CLIENT
HIGHCASTLE HOMES

PROJECT/LOCATION
RIVERWALK, PHASE 2
BRAMPTON, ON

DRAWING
SITE PLAN

SITE PLAN REVIEW

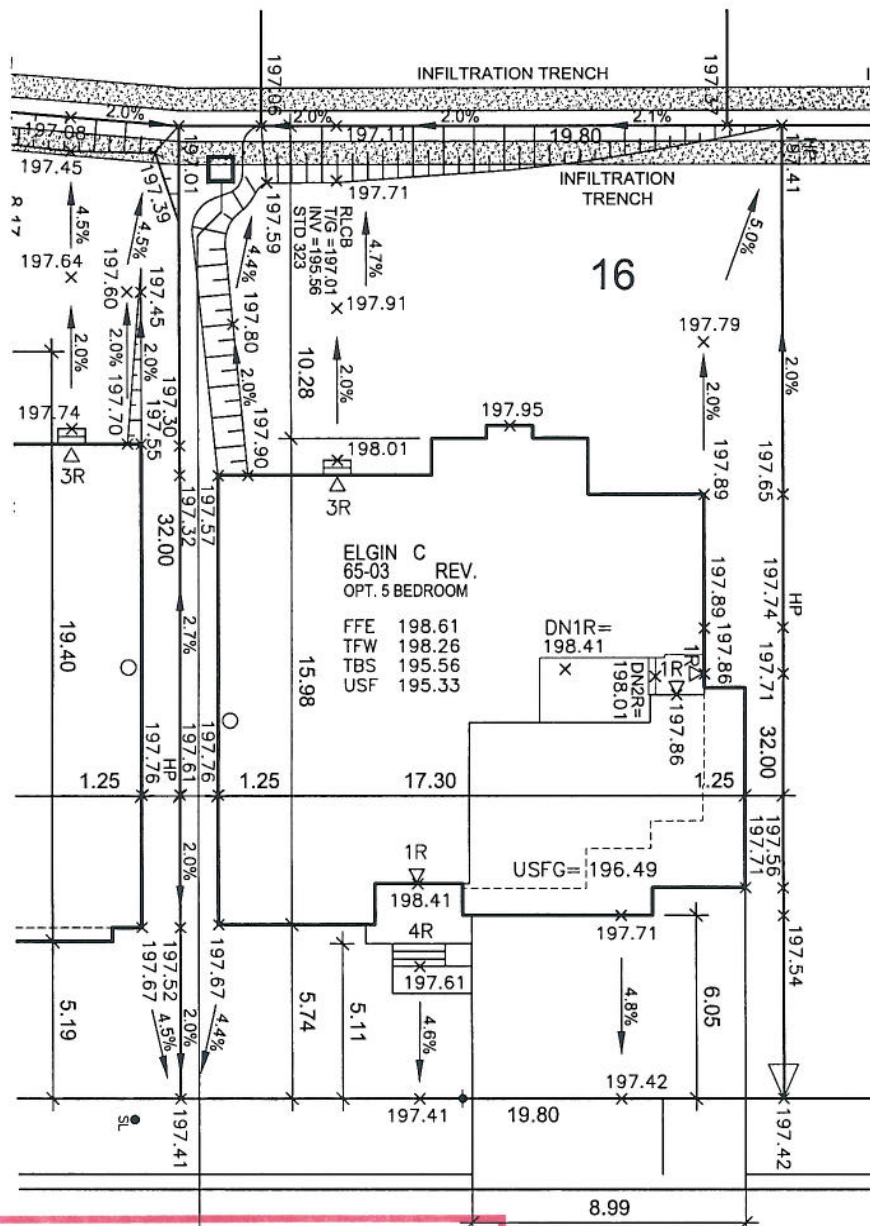
THE PROPOSED LOT GRADING AND DRAINAGE IS APPROVED AS BEING IN CONFORMITY WITH THE OVERALL APPROVED GRADING PLANS FOR THE SUBDIVISION.

NOTE:
RLCB LEAD PRESENT, CAUTION WHEN EXCAVATING.
BUILDER TO VERIFY ADEQUACY OF FOUNDING SOILS
ADJACENT TO RLCB LEADS.

SANITARY AND STORM INVERTS ARE NOT AVAILABLE
AT THE TIME OF SITING; BUILDER TO VERIFY
ELEVATIONS OF SANITARY AND STORM LATERALS IN
RELATION TO BASEMENT USF ELEVATIONS FOR
COMPLIANCE WITH MUNICIPAL STANDARDS PRIOR TO
EXCAVATION.
